Aviation DOA Nr.: EASA.21J.025	Technische Mitteilung / Service Bulletin	Dokument Nr.: SB-AT01-037
	Einbau verstärkte BFW-Schwinge / Installation of reinforced NLG-Fork	Ausgabe/Issue:A.02 Seite/Page: 1 of 1

Installation of a reinforced NLG-Fork.

A.02: Updated sketches in annex.
 Until now the standard NLG-Fork was often deformed or even destroyed during hard landings. A reinforced version is now available especially for flight school operations.

1. Exchange of Bolt

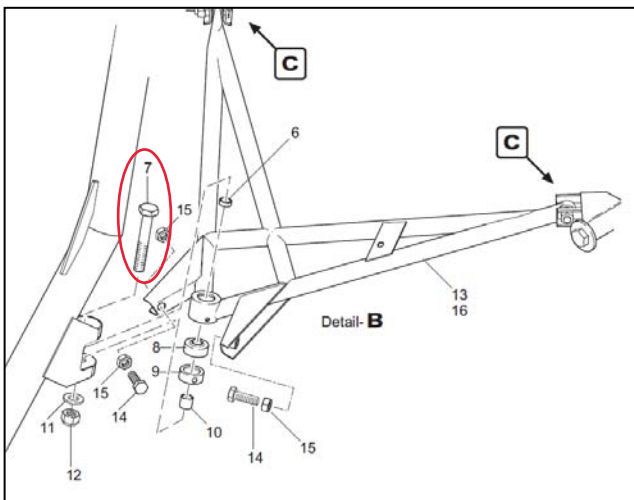
- exchange of bolt at supporting strut/NLG-strut
- exchange NLG-Fork
- exchange damper or retrofit
- if req. cut-out of NLG-Fairings

- LN-bolt M10x48 (1809037_10048)
- AT01-5110-005 „NLG-Fork, reinforced“
- AT01-5140-006 „Damper, 3 elements“ (oder 2x 5140-114 und 1x 5140-109)
